Case reference ABP 321238-24 for the development of a 110 kV electricity substation at Moyvannan, Co. Roscommon, approximately 7.5 km of underground electricity line and all associated works including a connection to the existing 110kV overhead line at Moyvannan.

I wish to object to the above SID application for the Moyvannan substation. Please find attached a detailed report outlining my observations.

1.0 Introduction

Figure 6

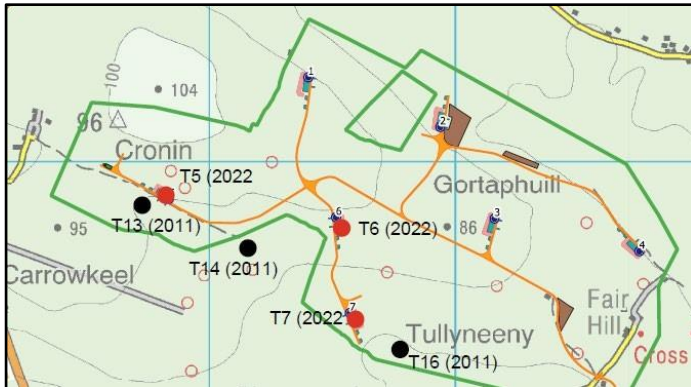
The red dots in Figure 6 show the locations of turbines T5, T6 and T7 granted permission ABP-313750-22 in Nov. 2023. The black dots show the locations of turbines T13, T14 and T16 granted permission ABP-239759 in Sept. 2013 and refused permission ABP-244346 in Feb. 2017

As expected, the 2011 geophysics align with those of 2022. The 2011 Waterwise interpretations along T13,14 and T16 align with the 2022 Apex interpretations along T05,T06 and T07. These results indisputably contradict the *Assessment Summary and Conclusion* in ABP-313750-22 EIAR Chapter 8: Land, Soils and Geology.

Figure 9: MWP Drg. 21337-MWP-WF-00-DR-C-3000

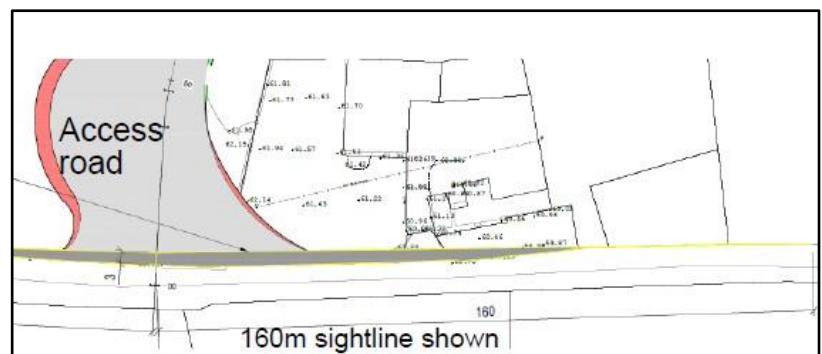
The sightline distance of 160m looking south as shown on MWP Drg. No. 21337-MWP-WF-00-DRC-3000 is currently not achievable.

Figure 10: Proposed substation superimposed on Apex Drg. 23061_4

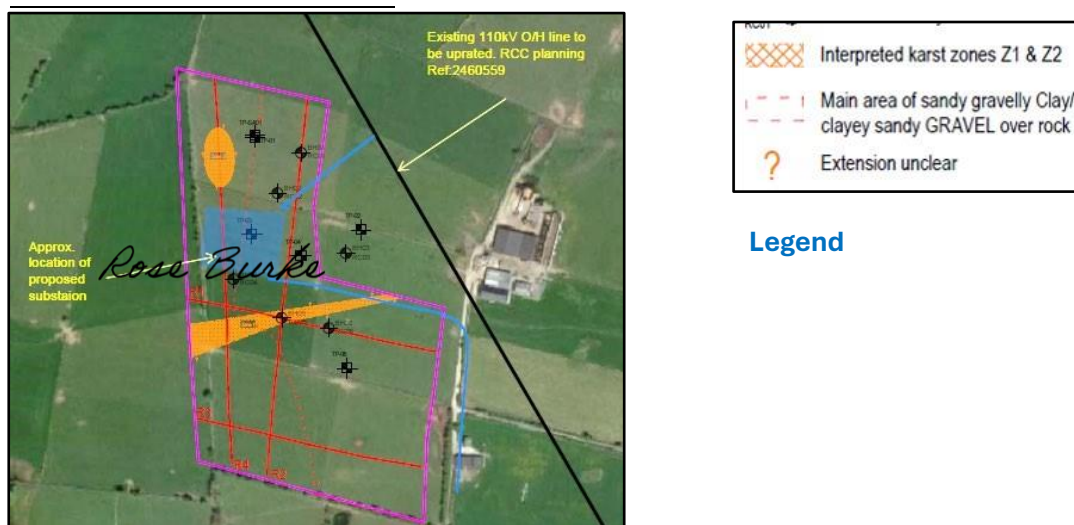
Figure 10 shows the proposed substation superimposed on Apex Drg. 23061_4

Two main zones of rock with a potential high degree of karstification with clay infill are interpreted across the site. One deeply penetrating zone (Z1) is present in the central part of the site. This zone is interpreted as a WSW – ENE feature shown on Drawing AGP23061_04 summary map. Borehole BH05/RC05 targeted this zone and encountered fractures with clay smearing, infilled cavities with sandy gravelly clay within highly weathered to slightly weathered to fresh rock over a depth range of 8.65 to 20.3 m bgl. A

second area of low resistivity values in the bedrock is present as a broader feature at the top of the rock at the NE of profile R4. This feature (Z2) penetrates to 22 m bgl.⁵

Figure 11: Known potential geohazards adjacent to granted and proposed developments

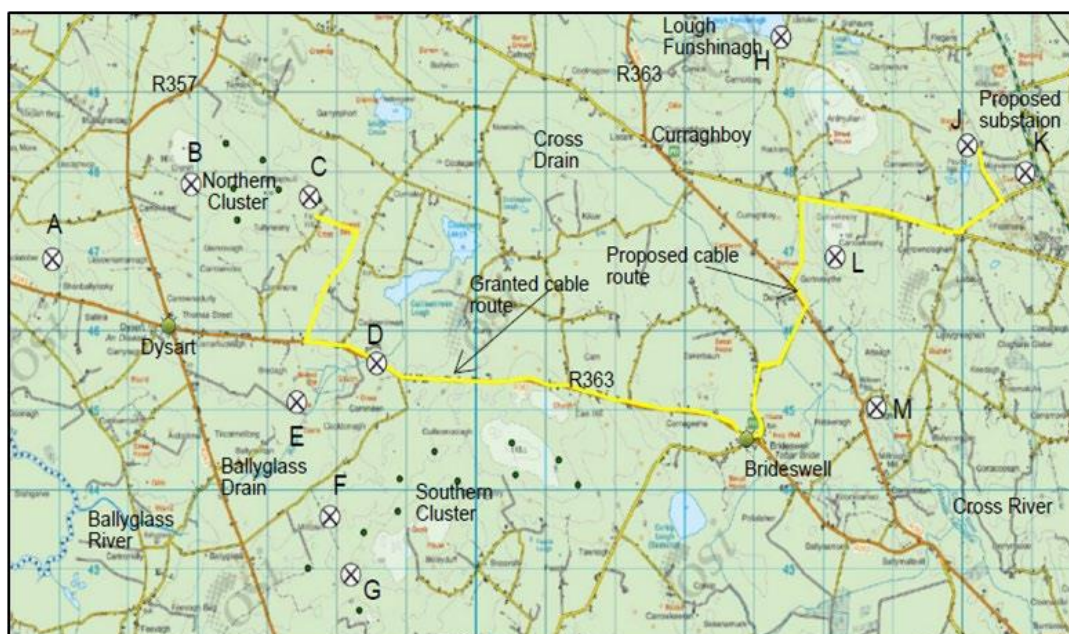
Figure 11 illustrates some of the known potential geohazards in and around the granted development and the proposed development.

Figure 12: Known geohazard, karst features, turloughs, caves etc adjacent to subject property.

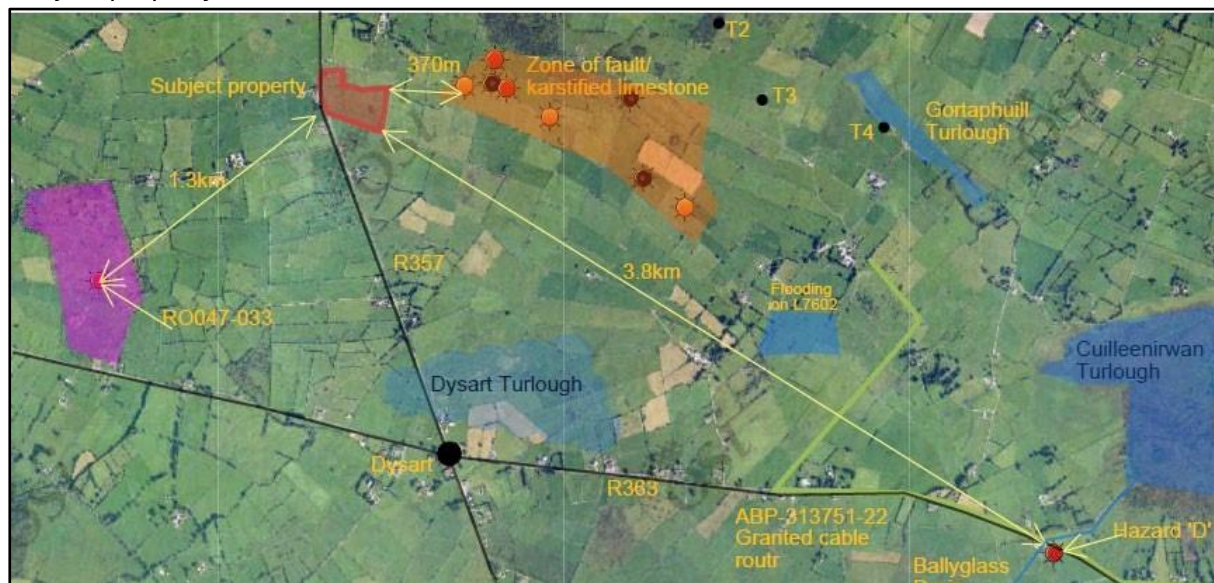
Figure 12 shows the geohazard, karst features, turloughs, caves etc in close proximity to the subject property.

There is no doubt that the area of the site is one of active karst (i.e. features continuing to develop with time). The presence of enclosed depressions, dolines, turloughs, small caves, the Burren like karren area at the adjoining townlands of Coolatober, Shanballylosky etc. are all clear evidence of this. The rate at which the large Turloughs, e.g. Cuilleenirwan, empty in the spring are evidence that drainage network in the rock comprises relatively large sized openings⁸

The area referred to by Dr. Long in his 2011 report is shown highlighted in purple in Figure 12. It is approx. 60 acres of pristine limestone karst, untouched by modern agricultural practices, it is located approx. 1.3km SW of the subject property.

Figure 16

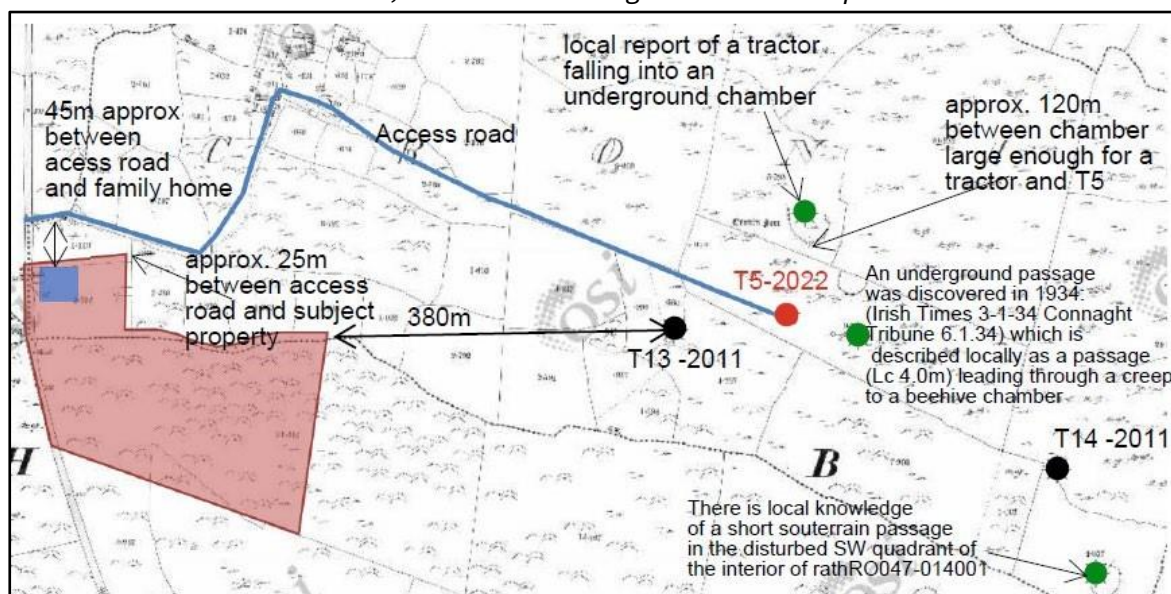
Figure 16 shows the 2011 turbines T13 and T14 and the T5 2022 turbine and the SMR locations and descriptions on the OSI 25" 1880 map. The 'rough pasture and cropping rock' has been cleared and dumped into the chambers, passages and souterrains and covered with topsoil.

The centre of Turbine T05 could as easily be described as minimum depth of topsoil over random sized loosely heaped boulders to a depth unknown.

Are all the passages, faults, chambers shown in Figure 16 connected – likely Is
